16 October 2022

RE: PART 1 ENVIRONMENTAL AUTHORIZATION AMENDMENT APPLICATION FOR THE CONSTRUCTION OF 75MW PV PLANT ON PORTION 1 OF THE FARM DROOGFONTEIN NO. 62 NEAR KIMBERLEY WITHIN SOL PLAATJIE LOCAL MUNICIPALITY IN THE NORTHERN CAPE PROVINCE

Figure 2: Google Earth imagery of the site for different dates.

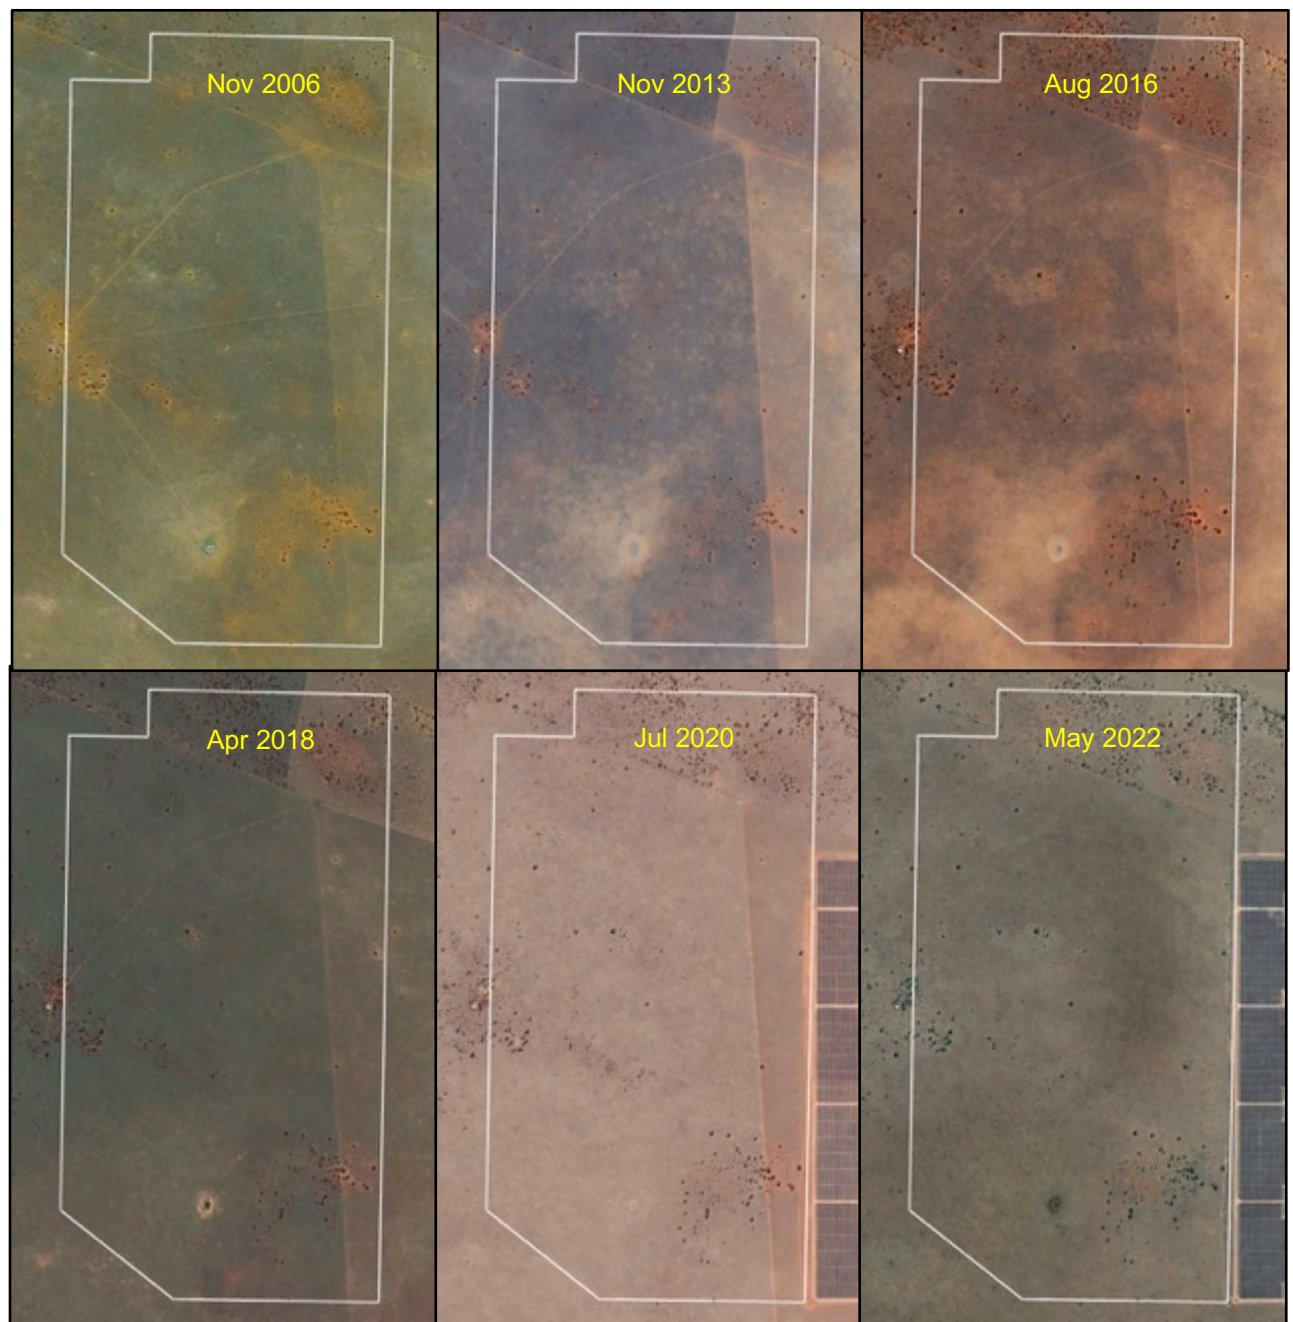
Google Earth provides historical aerial imagery that can be used to evaluate changes in a landscape over time. For the current site, detailed imagery is available as far back as 2006. Examples for the site from various dates going back in time are shown in Figure 2. At the time that the original ecological assessment was undertaken, imagery from Google Earth shows that the site was in a natural state, with one localised bare area in the southern half of the site that is probably a waterpoint for domestic livestock. There were also some vehicle tracks across the site. The vegetation appears from the imagery to be grassland with some concentrations of trees in places. From the report (Koch 2012), these are camel thorn trees. This pattern extends in all directions and for some distance away from the site. The relative uniformity of the area is confirmed from these images.

Imagery from Google Earth shows that there have been no changes on site over time. The vegetation pattern as originally described (Koch 2012) appears to have remained stable aside from the construction of the solar energy facility on the adjacent site in 2019. The general status and species composition of the site will be confirmed during an upcoming field assessment, but it is not expected that any fundamental changes will be observed. The preliminary conclusion is therefore that the baseline conditions on site have not changed.
